Addendum

Reconstruction at
Mahopac High School
Mahopac Middle School
Mahopac Falls School
Bus Garage
New Pump House

BID Addendum No. 3
to
Drawings and Project Manual

February 22, 2021

Single Line Diagram

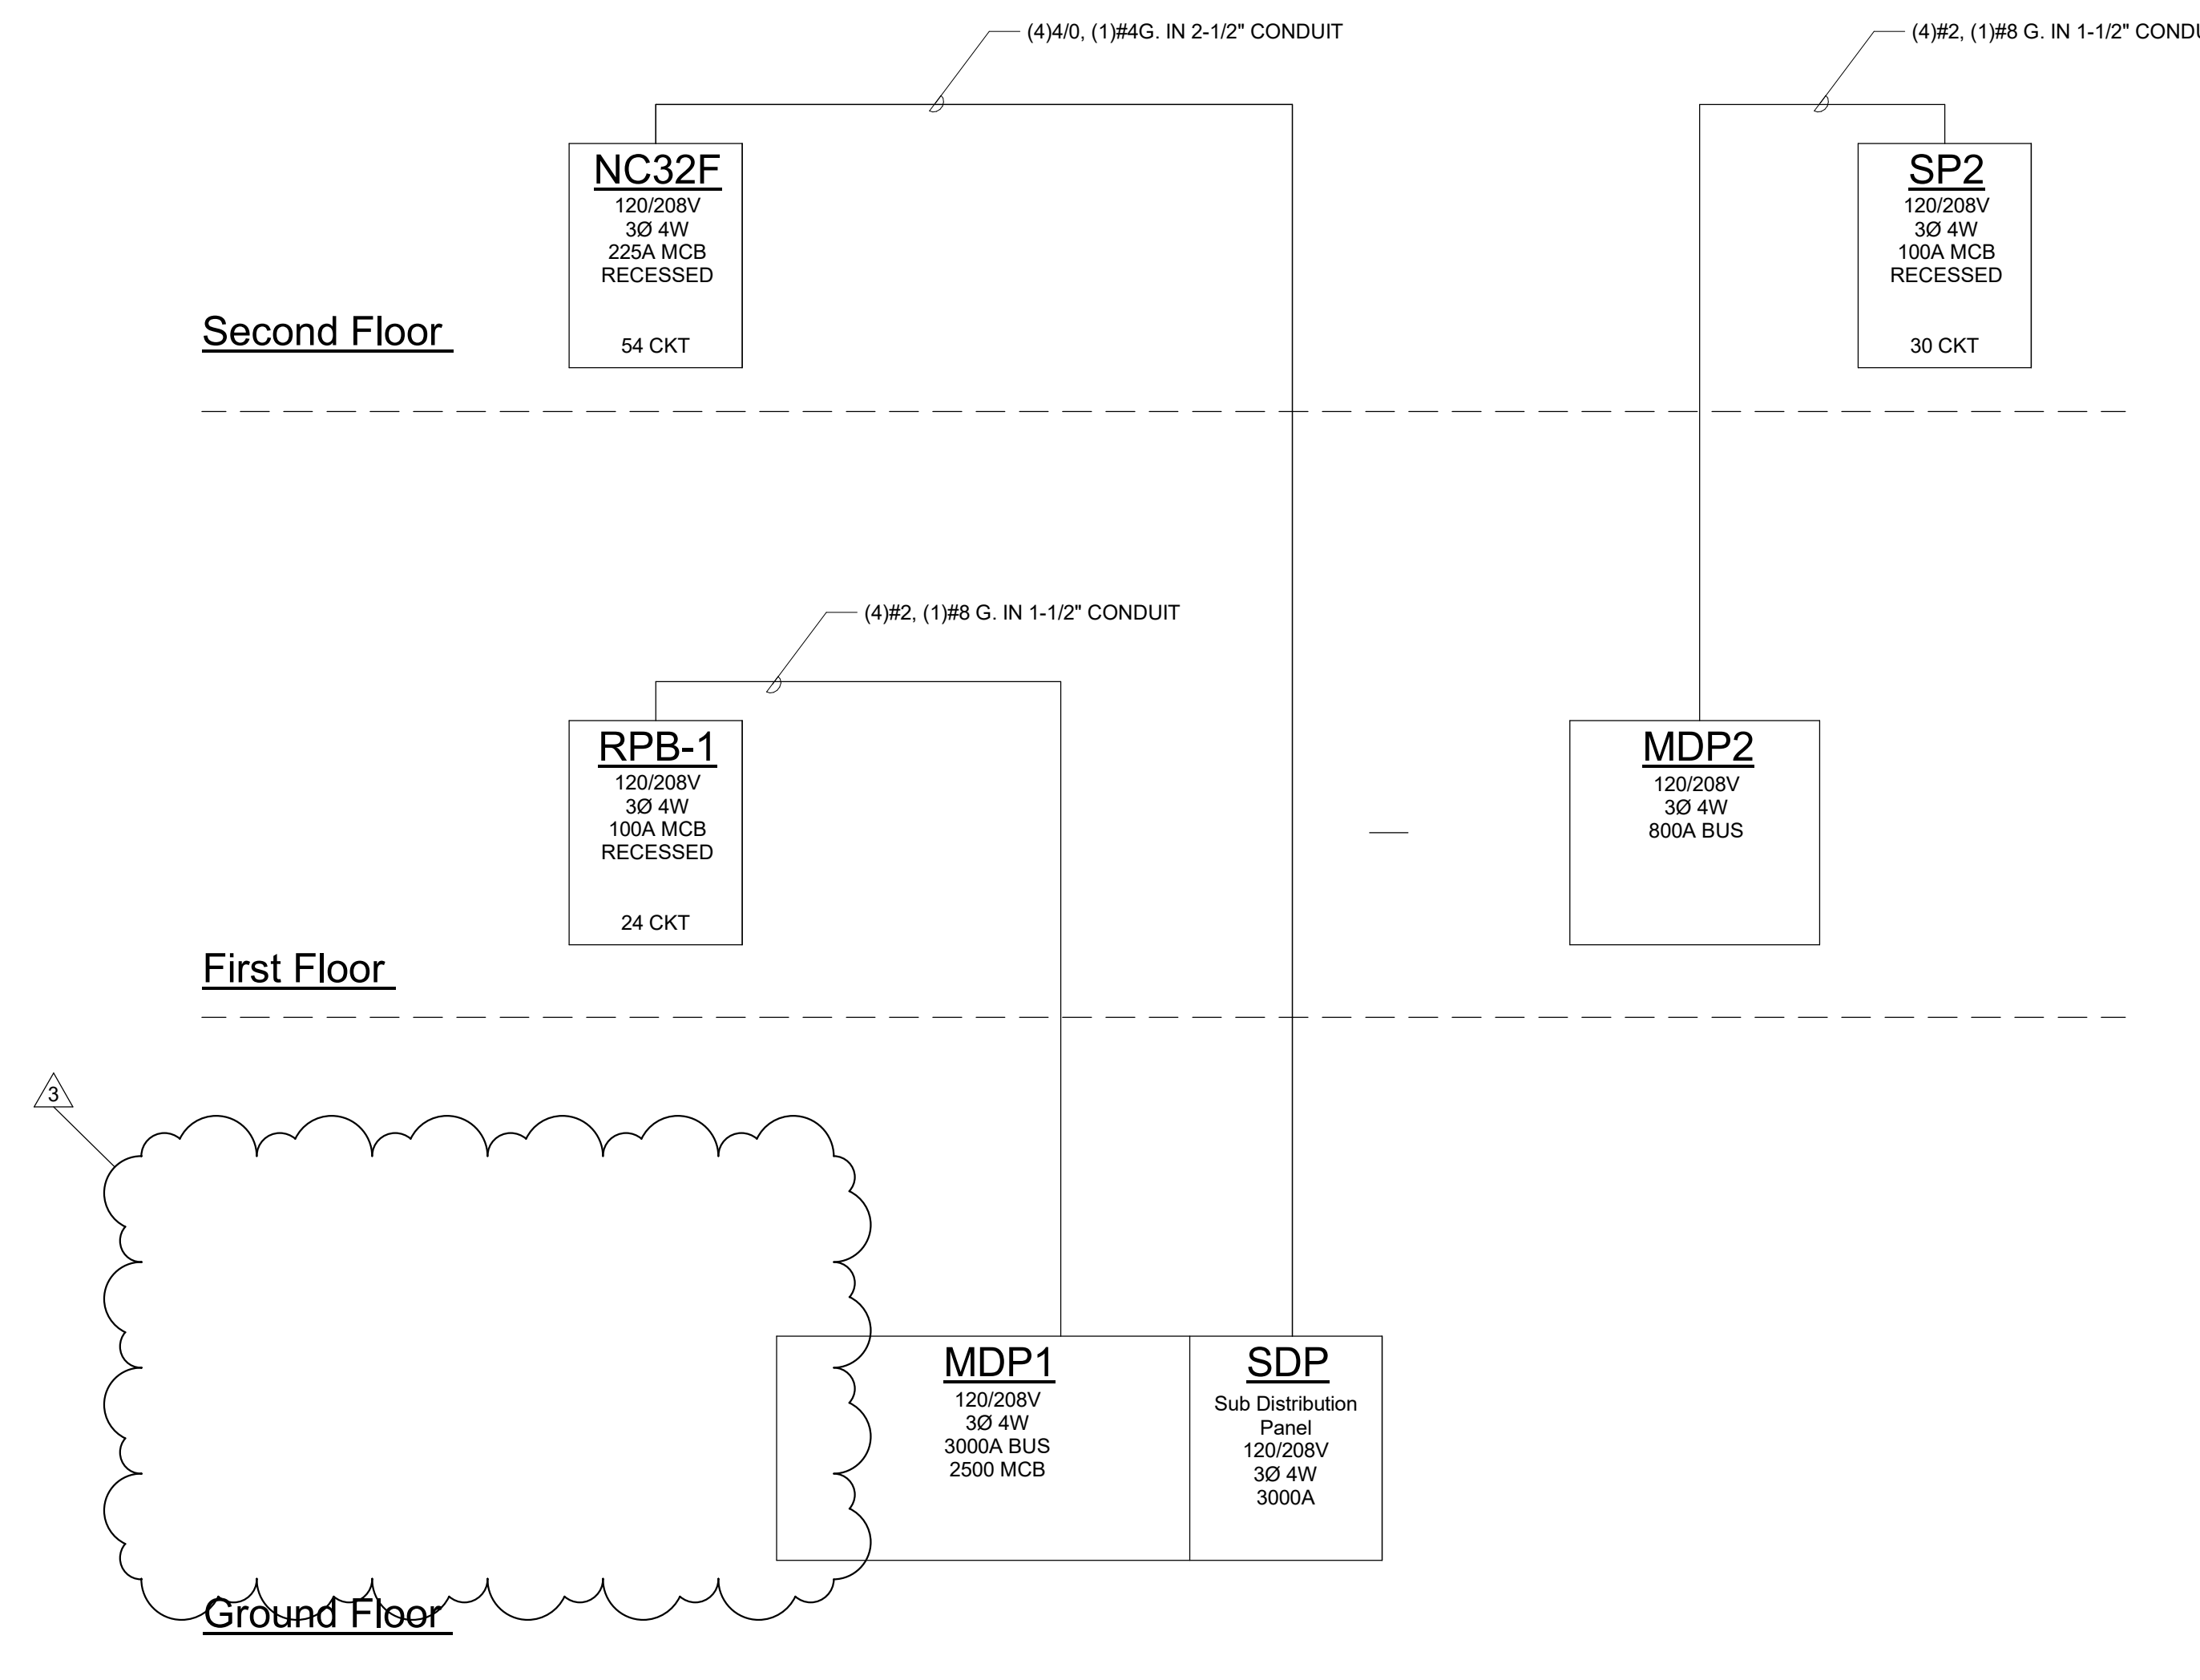
On AE700 the new feeder for the new panel PH-1 is shown from MDP1 in the basement of the High School. It is clear that the pump house building is no where near the High School, and on AE003 it clearly is shown fed from the Academy School. Other than the site drawing on AE003 we have no idea where the Custodial room, existing MDP is in the Academy School, or what type of building structures we will need to penetrate. Kindly provide the location of the panel MDP where we are to get this new service from.

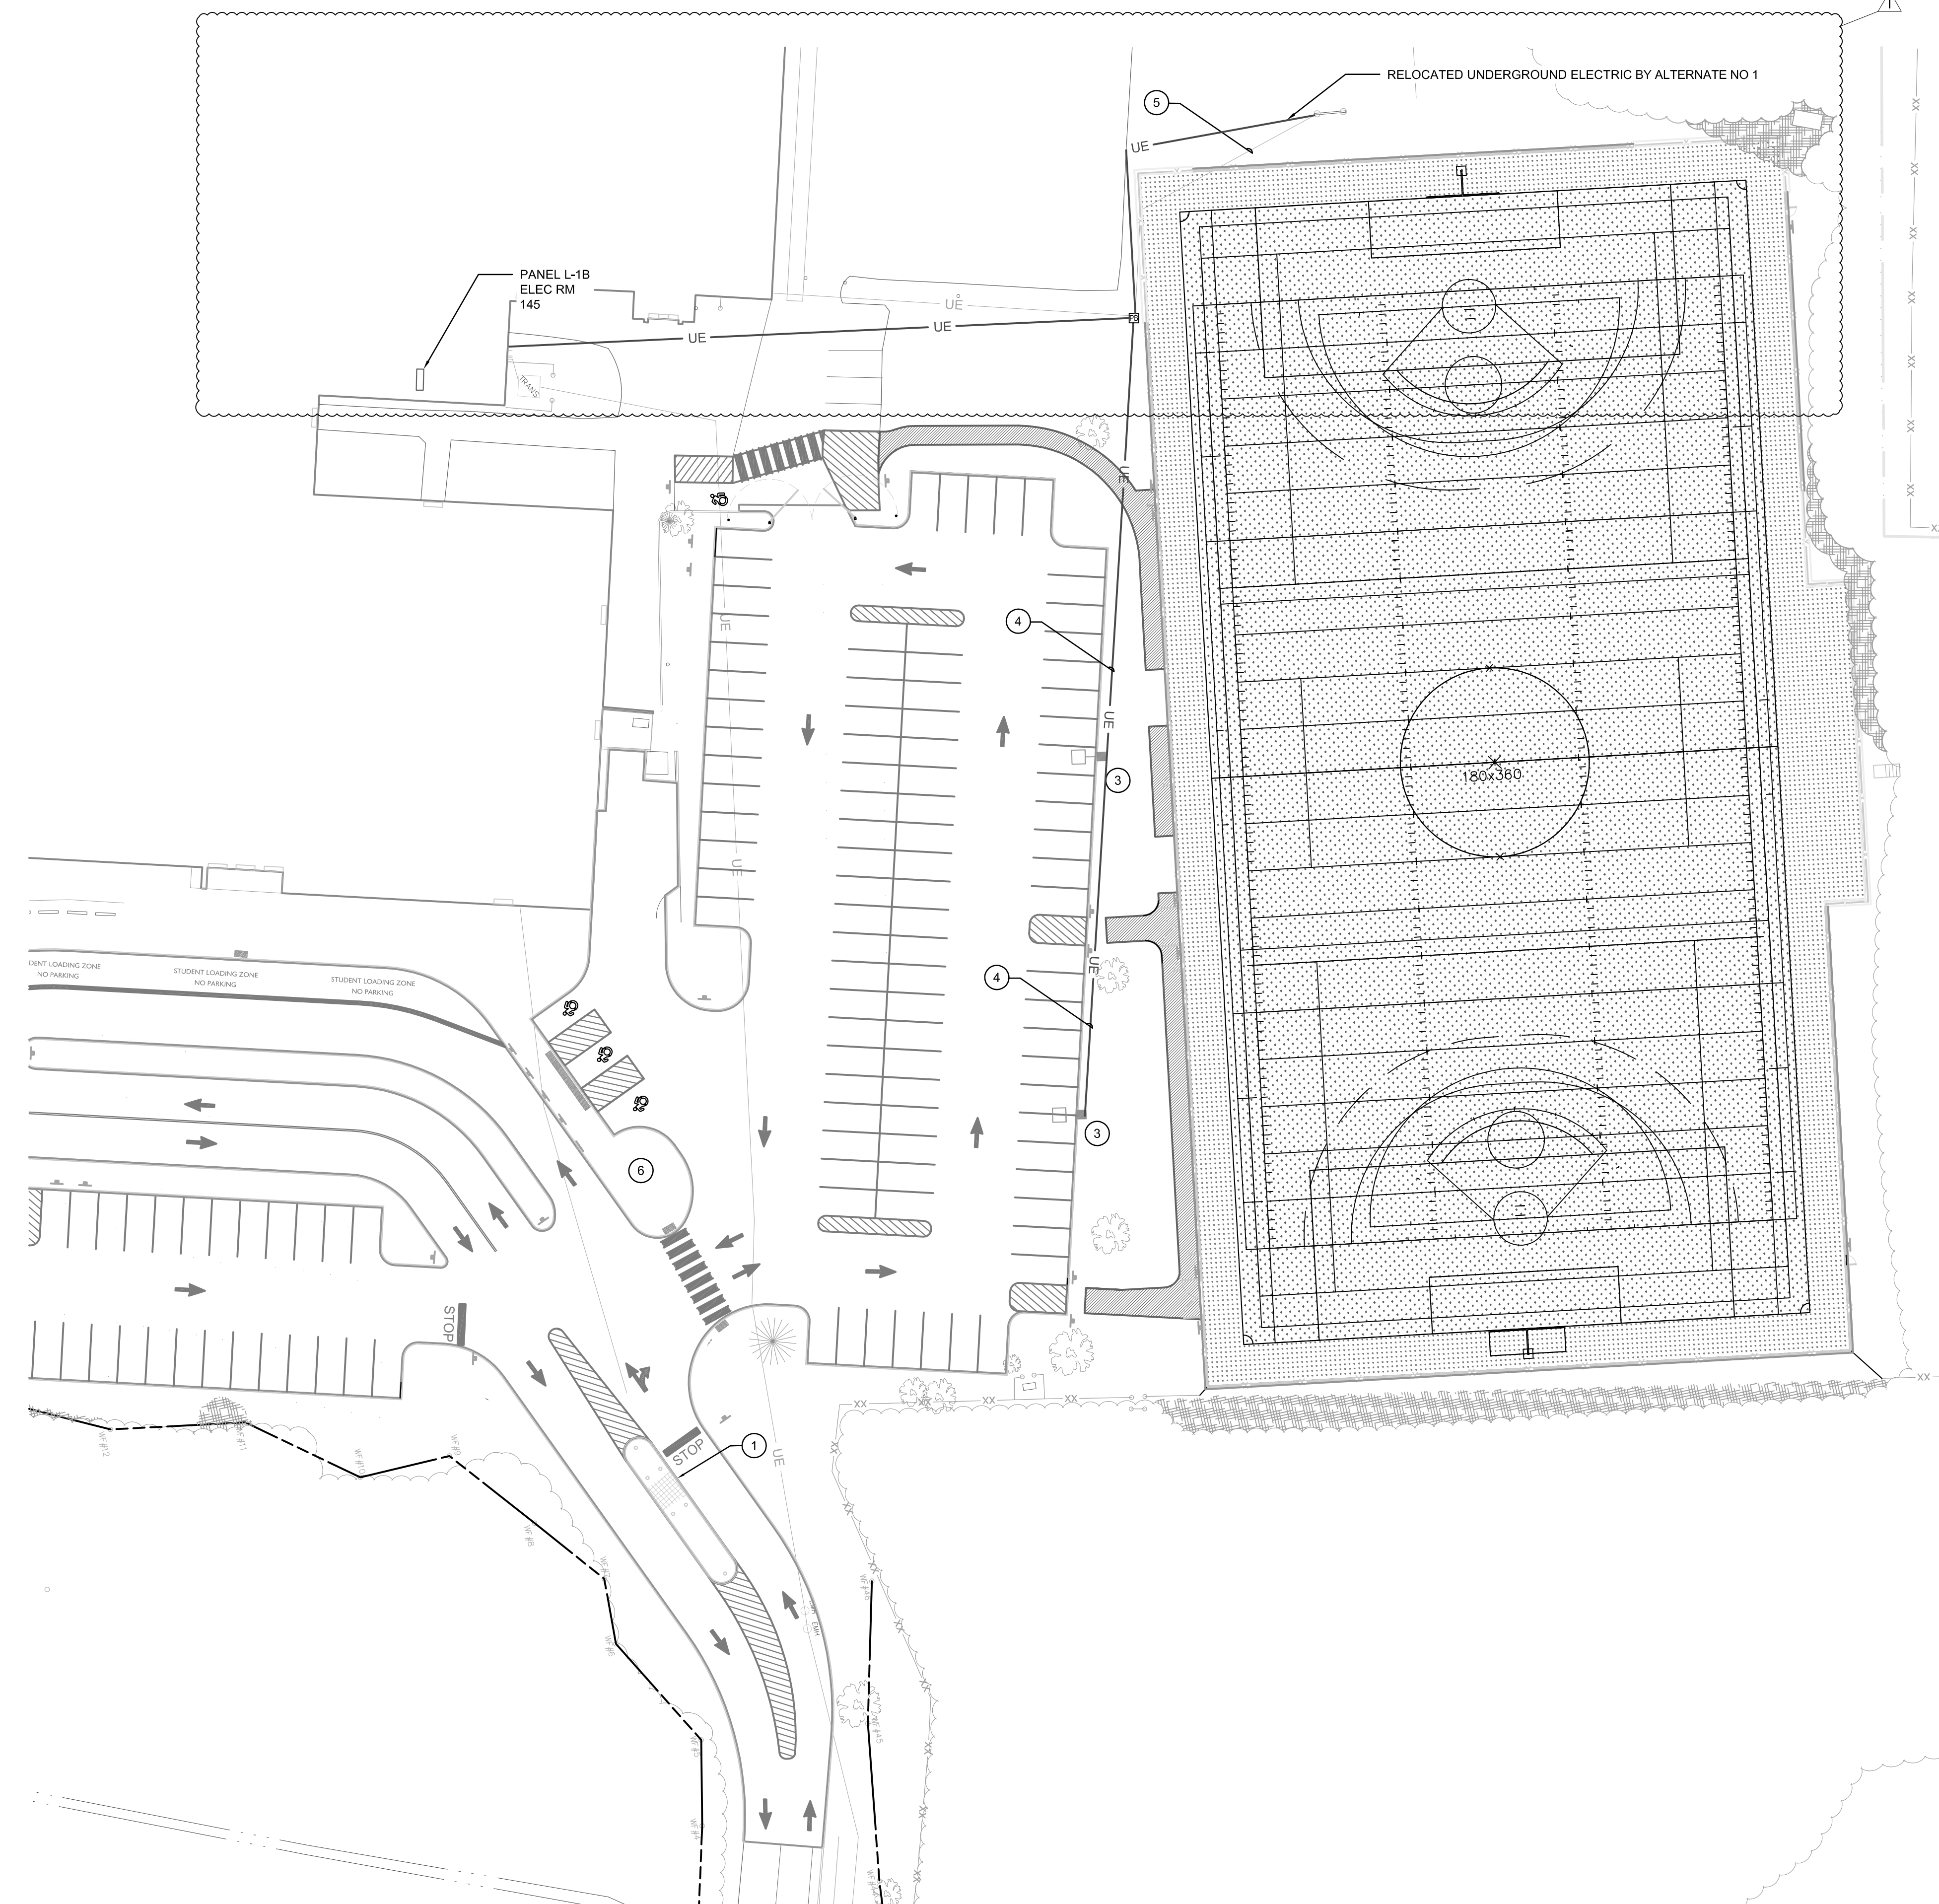
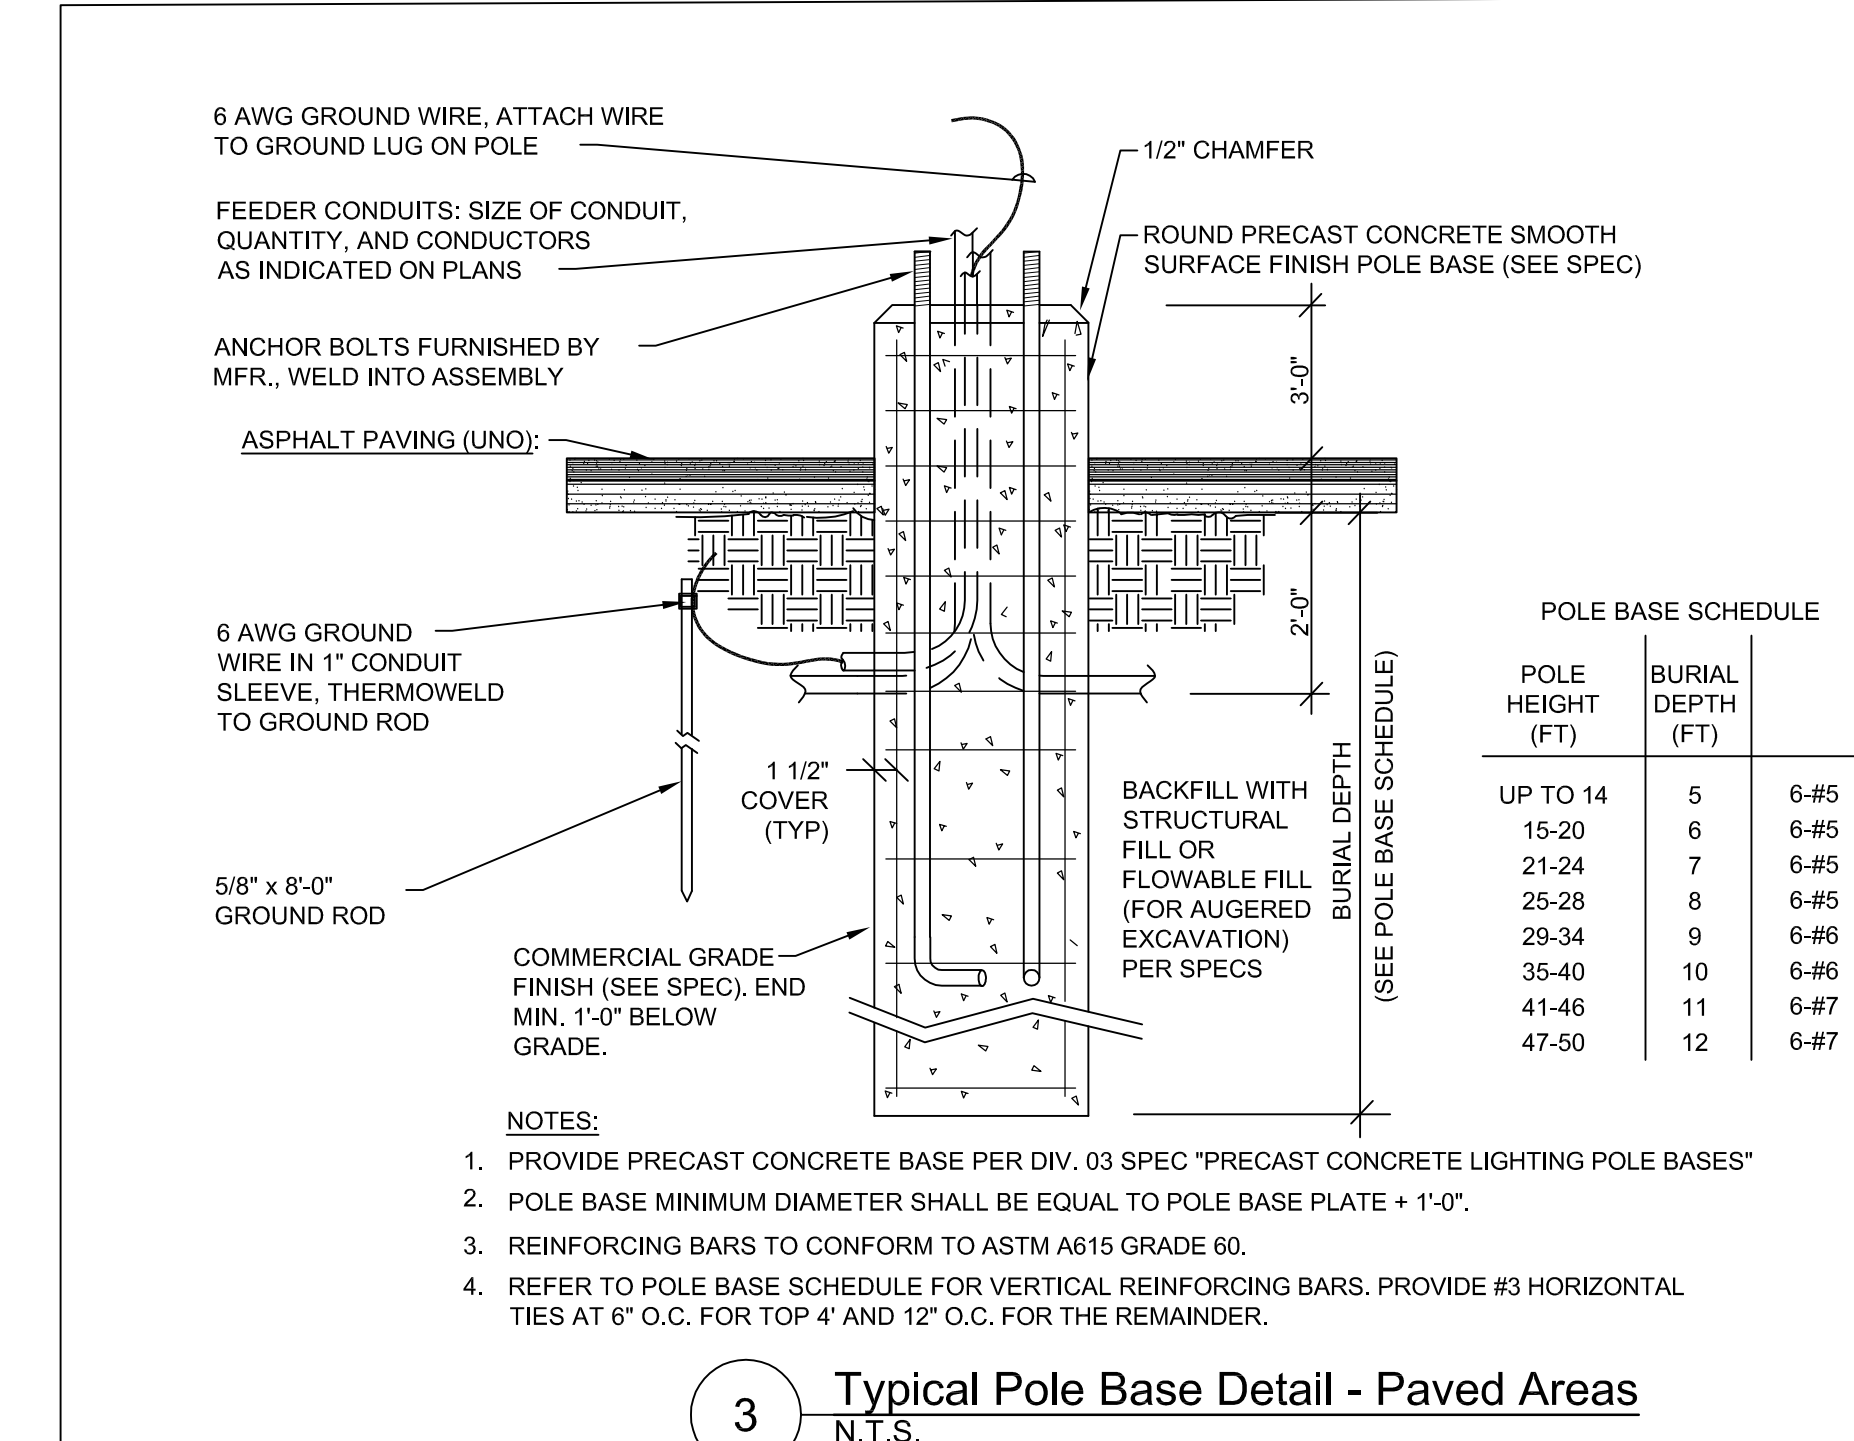
Question: (Please be specific) 1. note 1 on BE001, clarify scope. Where are we extending this existing circuit to and from? noted 2 is not shown on plans for new location. Also provide size of conduit and cable for us to extend?

2. note 3, to what circuit are we wiring the pole receptacles to? to panel L-1B? where is panel L-1B located, plans do not show. Neither does BE160? there is no room 145? please provide location

3.note 4 circuit for new 20' light poles is new pipe and wire correct, there is not existing circuit out there for us to intercept? please clarify/ confirm scope?

4. note 5 for Alternate: can you please clarify the exact scope. where are is the existing circuit that we are relocating to the scoreboard? can you provide old location and new location, feeder size so we know what we are relocating and possibly extending?

Question: (Please be specific) 1. spec bid form list the athletic field as the alternate, but drawing BE001 note 5 only list the relocation of circuit as the alternate. Please clarify what scope of work goes in the Alternate, just note 5 scope or the entire BE001 Athletic field scope of work shown?

- 1. REFER TO BID ADDENDUM NO 3
- 2. REFER TO BID ADDENDUM NO 3
- 3. CONFIRMED, NEW CONDUIT AND WIRE.
- 4. REFER TO BID ADDENDUM NO 3
- 5. CONFIRMED, REFER TO BC DRAWING.

ALTERNATE ON BE001 IS NOTE 5 ONLY. REFER TO BC PLANS FOR ATHLETIC FIELD ALTERNATES.
